# Access Compliance Report

## Public Rights-of-Way

### (Pedestrian Signals)

| ADA ID: 792C940D8CBF                    | Signal Type: One Push Button-APS | Overall Compliance: No                  | Severity Score: BTN 1: N/A BTN 2: N/A No BTN: N/A |

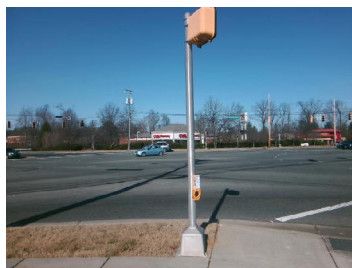
| Compliance | Description                             | Data    | Compliance | Description                            | Data         |
|------------|-----------------------------------------|---------|------------|----------------------------------------|--------------|
| No         | B 1 Clear Floor Space XSlope (%)        | 6.9     | N/A        | B 2 Clear Floor Space XSlope (%)       | N/A          |

| No B 1 Verbal Walk Cycle?           | Yes | N/A B 2 Verbal Walk Cycle?          | N/A |

Possible Solutions: Remove & Replace  
Replace APS Button With New APS Button.  
Remove and Replace Clear Space.
